ORDER FOR MODIFICATION OF LICENSE

SAFETY EVALUATION REPORT

VERMONT YANKEE NUCLEAR POWER STATION

OPERATION WITH PLUGGED BYPASS FLOW HOLES

FIGURE 2  
AVERAGE PLANAR EXPOSURE (MWD/IT) - MAXIMUM ALLOWABLE PLANAR LHGR

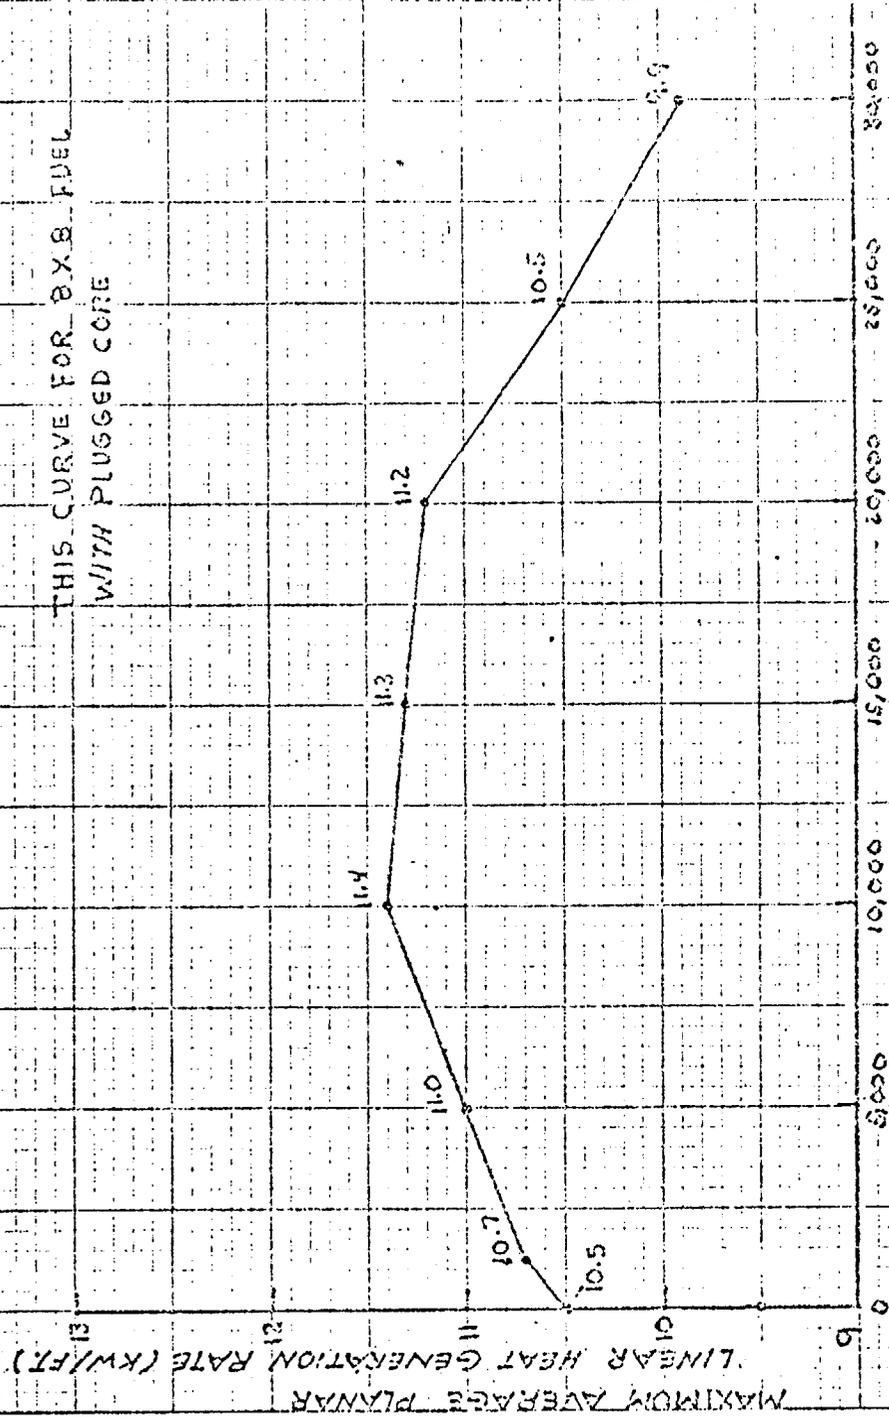
We modified the 8x8 type fuel MAPLHGR curve, Figure 2, using as a basis the most recent analytical methods in the licensee's submittal of July 30, 1975.
